TRANSMITTAL OF DEFENSE NUCLEAR FACILITIES SAFETY BOARD (DNFSB)
RECOMMENDATION 2010-2 IMPLEMENTATION PLAN (IP) DELIVERABLE 5.5.3.4

Waste Feed Delivery Mixing and Sampling Program Plan and Test Requirements

Subject: Review of *Waste Feed Delivery Mixing and Sampling Program Plan and Test Requirements* (ERT-2011-6)

REVIEW COMMENT RECORD (RCR)

Figure 1-1. Mixing and Sampling Program Integrated Schedule

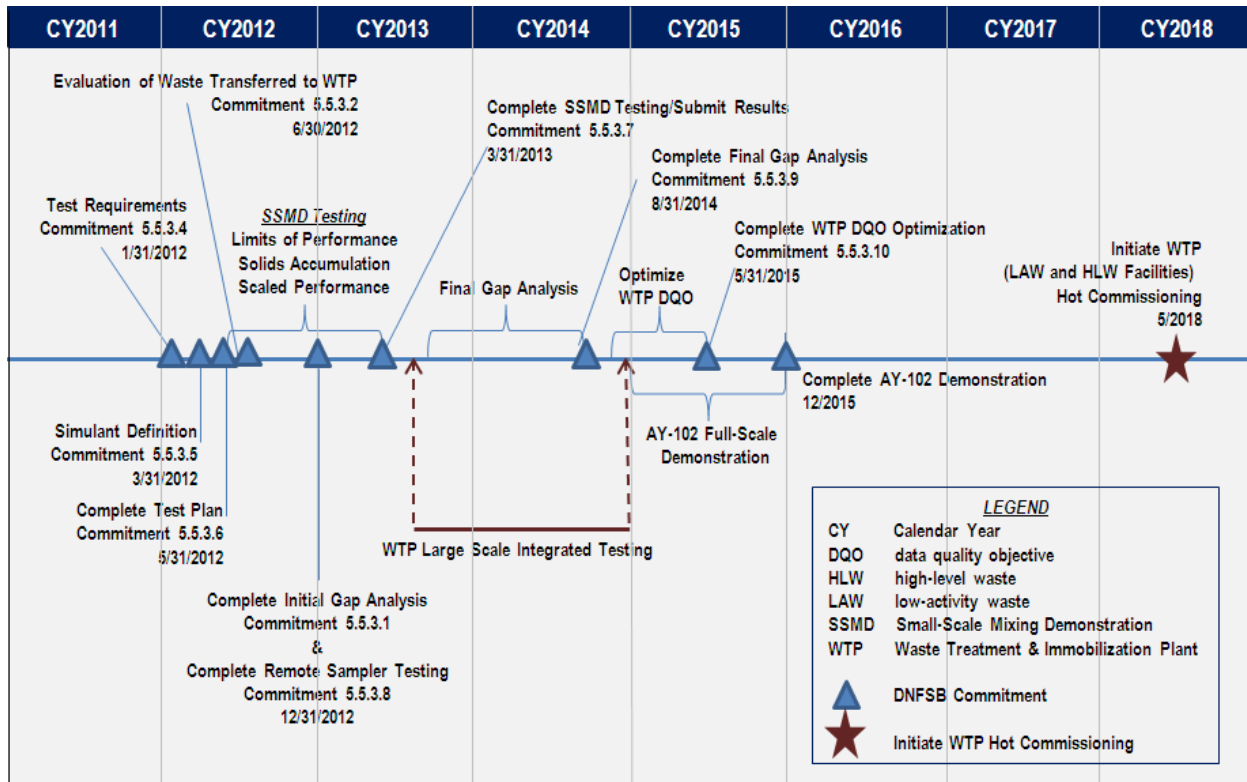
(6) Document Title: Waste Feed Delivery Mixing and Sampling Program Plan and Test Requirements			
(7) Change/Release Description: Figure 1-1 was revised to include corrections.

(8) Change Justification: Figure 1-1 required corrections.			
(9) Associated Structure, System, and Component (SSC) and Building Number:	(a) Structure Location: N/A	(c) Building Number: N/A	(e) Project Number: N/A
